# NW Ceiling Lifts

**City of Puyallup Development Engineering APPROVED**

Site Address:  
Multicare Rehab  
Good Samaritan Hospital  
401 15th Ave SE  
Puyallup, WA 98372

Project:  
Install 01 Patient Lift  
on Level A

## 4 SUPPORT CONNECTION AT DECK

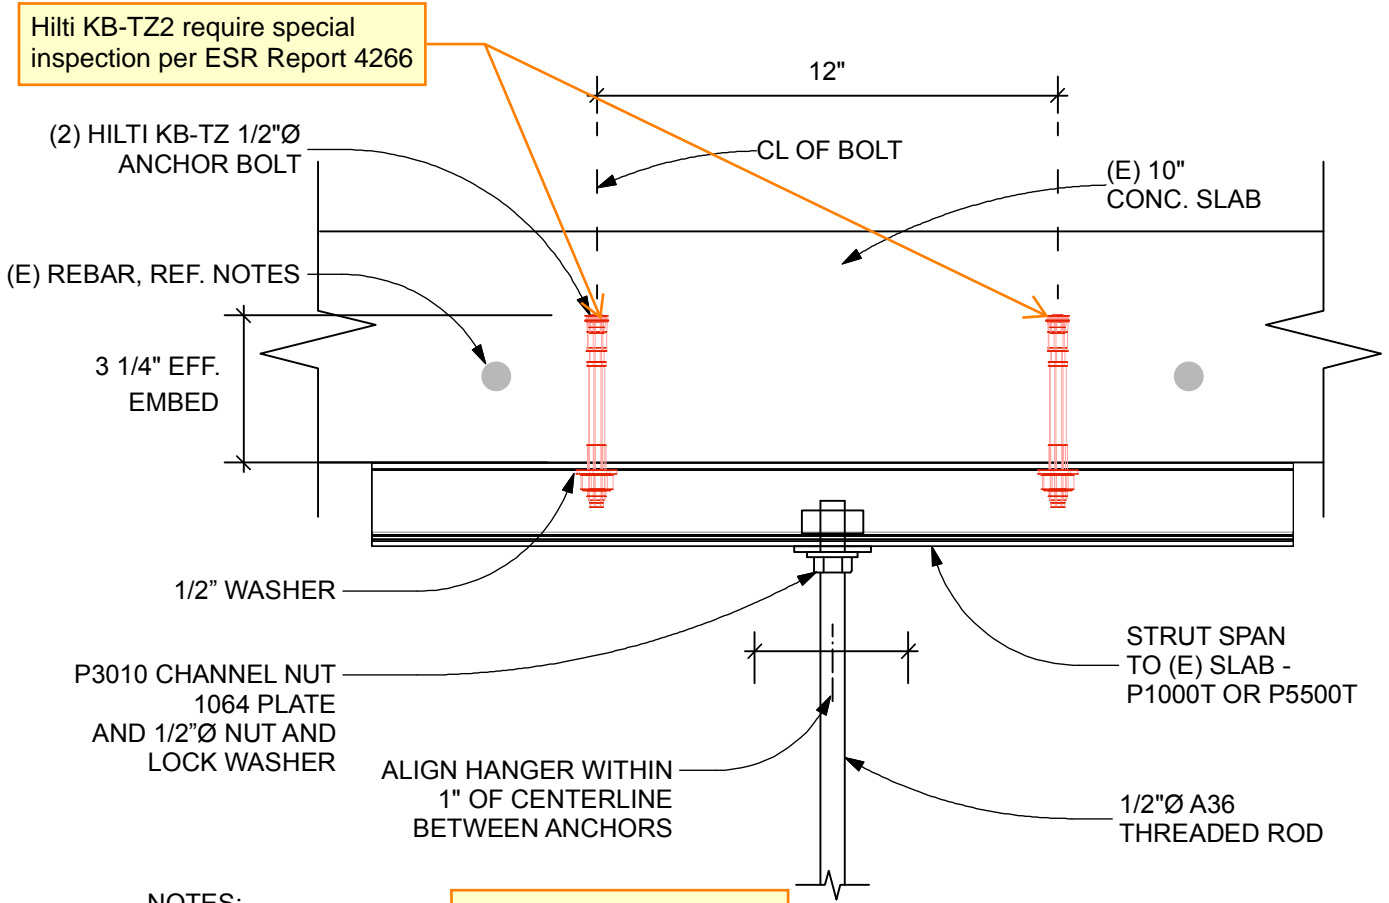
ESR-4266 for Hilti KB-TZ2

1. INSTALL ANCHORS IN ACCORDANCE W/ MANUFACTURERS INSTRUCTIONS, ~~ESR-1044~~, INCLUDING PERFORMING PERIODIC INSPECTIONS. INSPECTIONS TO BE COORDINATED BY OWNER/ARCHITECT/CONTRACTOR.
2. ROD STIFFENER REQUIRED IF ROD LONGER THAN 21". REF. 6/S406.
3. DO NOT DAMAGE REBAR IN (E) SLAB.
4. RELOCATE BOLTS TO AVOID (E) REBAR.

Prior to installation:

Review anchor product's ESR and install the product per the report. If special inspection(s) are required - the final special inspection report must be on site during City inspections.

**5** BRACE CONNECTION AT DECK

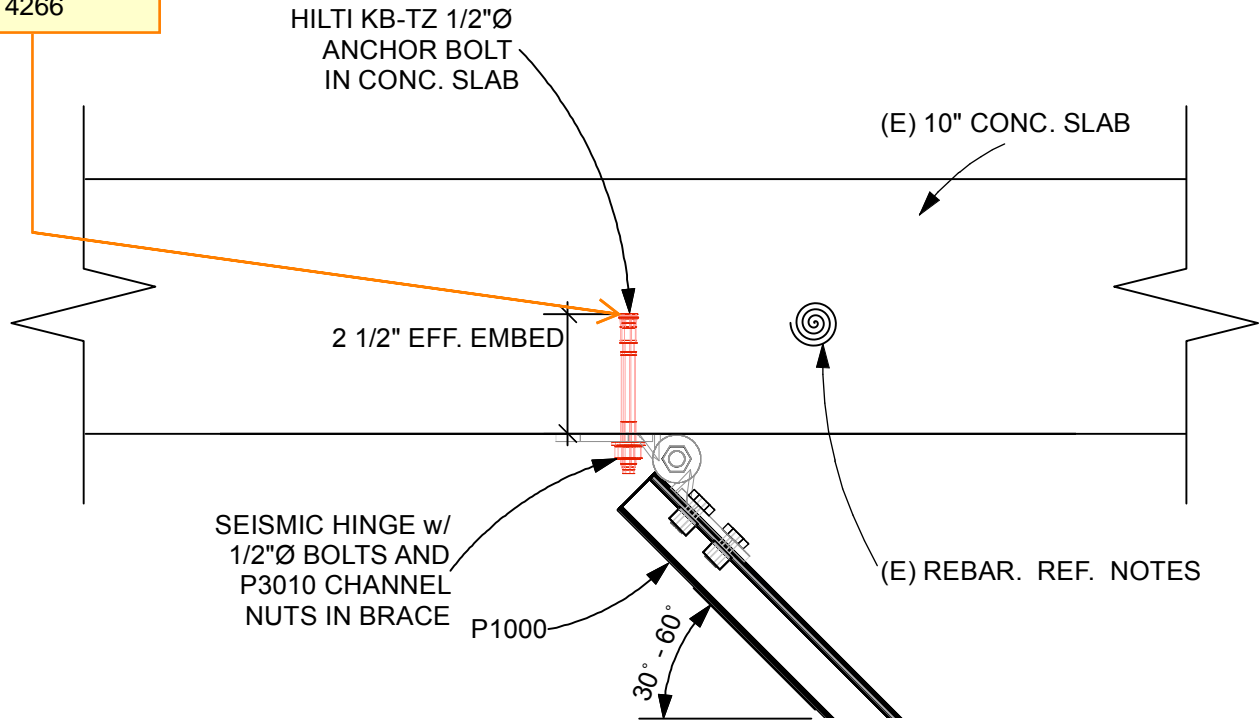
Hilti KB-TZ2 require special inspection per ESR Report 4266

ESR-4266 for Hilti KB-TZ2

Prior to installation:  
Review anchor product's ESR and install the product per the report. If special inspection(s) are required - the final special inspection report must be on site during City inspections.
